Item Name: Floor Provisions - Energy Attenuating Seat Compatible

DART SERVICE INSTRUCTION

TO AMEND INSTALLATION INSTRUCTIONS IIN-D350-689 REV. B AND INSTRUCTIONS FOR CONTINUED AIRWORTHINESS ICA-D350-689 REV. 1

REF. TCCA STC: SH02-33
REF. FAA STC: SR01620NY
REF. EASA STC: EASA.IM.R.S.01453
REF. TCA STC: 2005S03-09

FIGURE 1: UPDATES TO CROSS SECTIONS F-F AND M-M
With reference to Figures 5 and 7 of IIN-D350-689
(Figures 25-5 and 25-7 of ICA-D350-689)

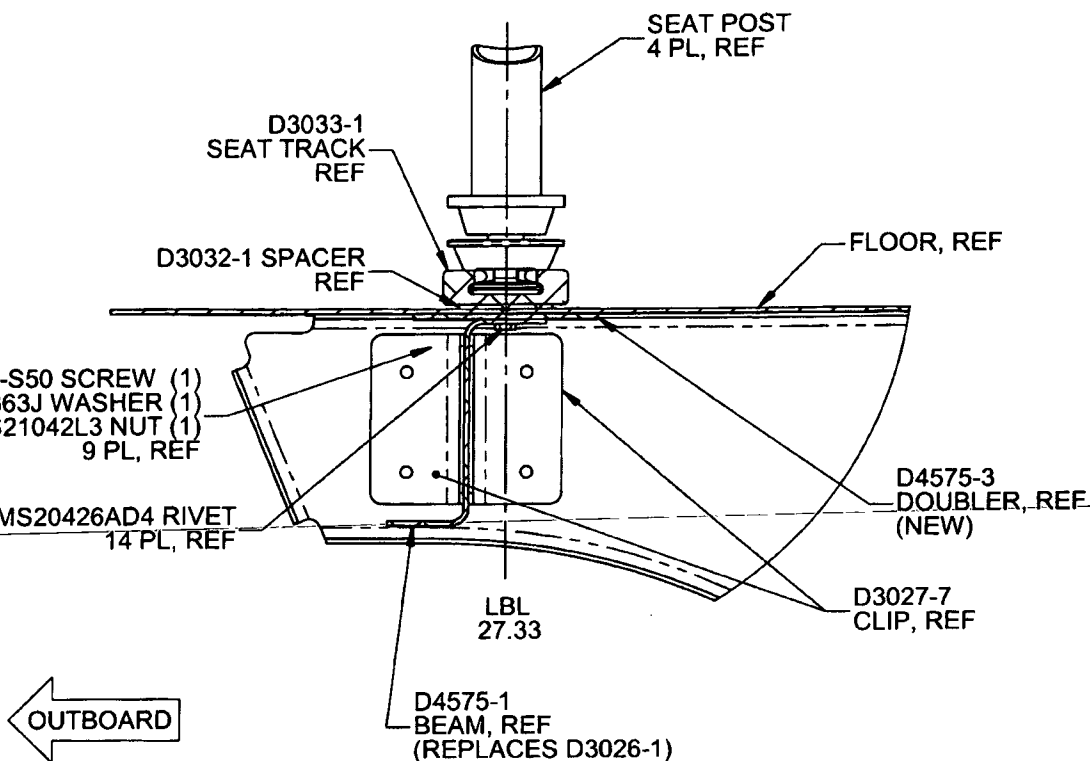
If there is an existing stringer at LBL 27.33, it will need to be removed from that location. Locate D4575-1 Beam, D4575-3 Doubler, and D3032-1 Spacer as shown in Figure 1 of this Service Instruction. Transfer drill existing holes from the aircraft floor to the D4575-1 Beam, D4575-3 Doubler, and D3032-1 Spacer. Ensure 1.0" to 1.5" rivet pitch and add additional holes if required. If there is no existing stringer, locate D4575-1 Beam, D4575-3 Doubler, and D3032-1 Spacer as shown in Figure 1 of this Service Instruction and drill Ø0.128" holes on a 1.0" to 1.5" pitch.

If there is an existing stringer at LBL 27.33, it will need to be removed from that location. Locate D4575-1 Beam and D4575-3 Doubler as shown in Figure 2 of this Service Instruction. Transfer drill existing holes from the aircraft floor to the D4575-1 Beam and D4575-3 Doubler. Ensure 1.0" to 1.5" rivet pitch and add additional holes if required. If there is no existing stringer, locate D4575-1 Beam and D4575-3 Doubler as shown in Figure 1 of this Service Instruction and drill Ø0.128" holes on a 1.0" to 1.5" pitch.

FIGURE 3: RELIEFS ON D4575-1/-3
(ONLY D4575-1/-3 SHOWN FOR CLARITY)
VIEW LOOKING INBOARD

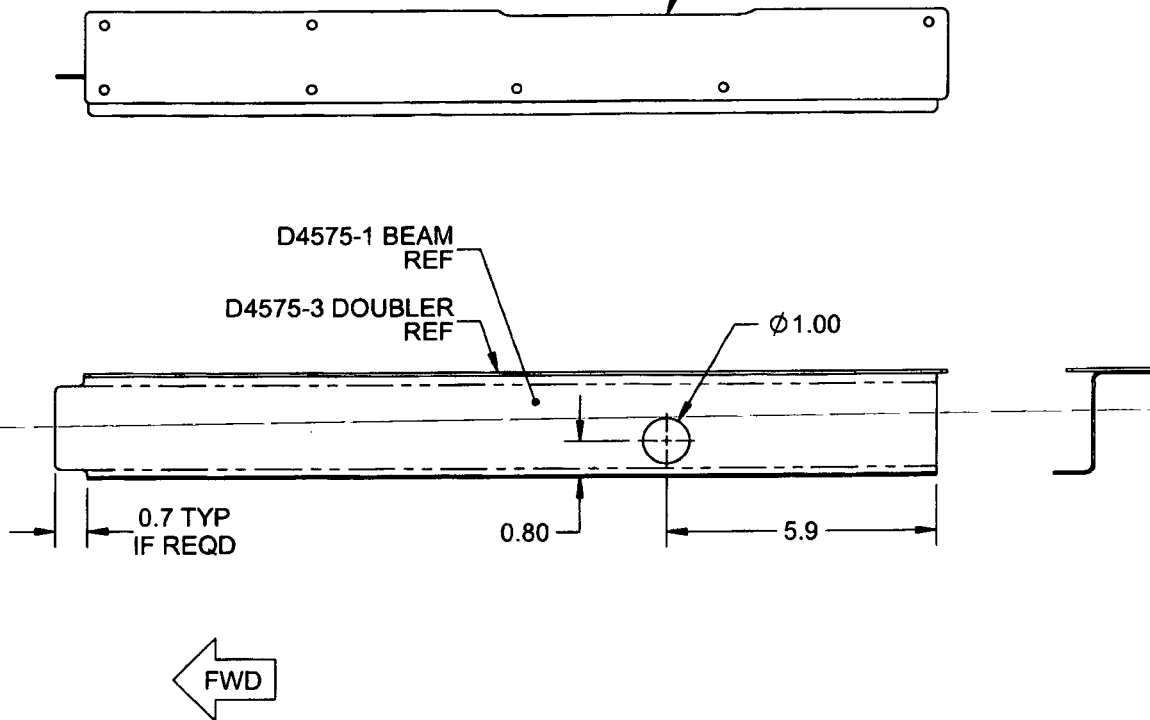
Note: Drill a Ø1.00" (Ø25.4 mm) hole in the D4575-1 Beam to clear extension tube of collective and cutout as required for clearance of collective opening and fwd bulkhead as shown in Figure 3 of this Service Instruction.

Note: Drill a Ø1.00" (Ø25.4 mm) hole in the D4575-1 Beam to clear extension tube of collective and cutout as required for clearance of collective opening and fwd bulkhead as shown in Figure 3 of this Service Instruction.

TRANSFER EXISTING CUTOUT
FROM AIRCRAFT FLOOR A/R TO
D4575-1/-3 FOR COLLECTIVE OPENING
